California Department of Transportation

November 7, 2023

SCH #: 2023100356
GTS #: 04-SCL-2023-01229
GTS ID: 31132
Co/Rt/Pm: SCL/101 /36.365

Re: Julian & Tripp Mixed-Use Development - Mitigated Negative Declaration (MND)

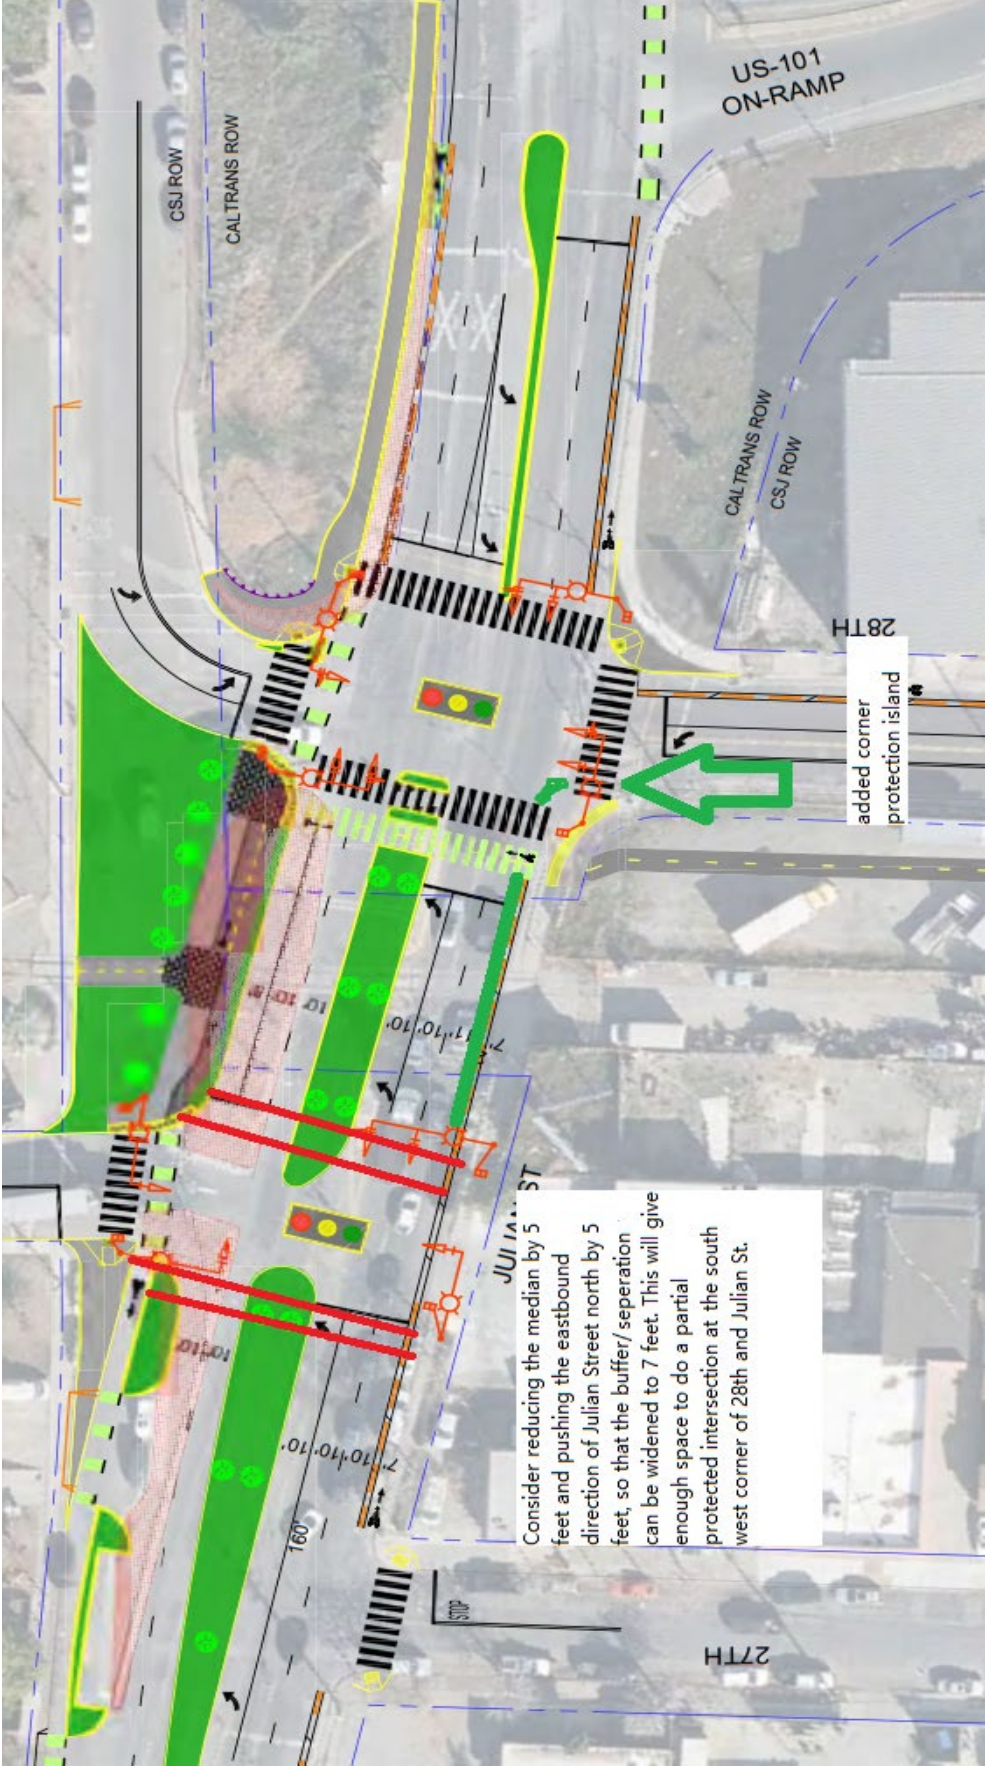
Please consider reducing the median by 5 feet and pushing the eastbound direction of Julian St north by 5 feet, so that the buffer/ separation can be widened to 7 feet. This could give enough space to do a partially protected intersection (corner protection island) at the southwest corner of 28th St and Julian St. Please see the enclosed figure with annotations.

added corner
protection island

Consider reducing the median by 5 feet and pushing the eastbound direction of Julian Street north by 5 feet, so that the buffer/separation can be widened to 7 feet. This will give enough space to do a partial protected intersection at the south west corner of 28th and Julian St.
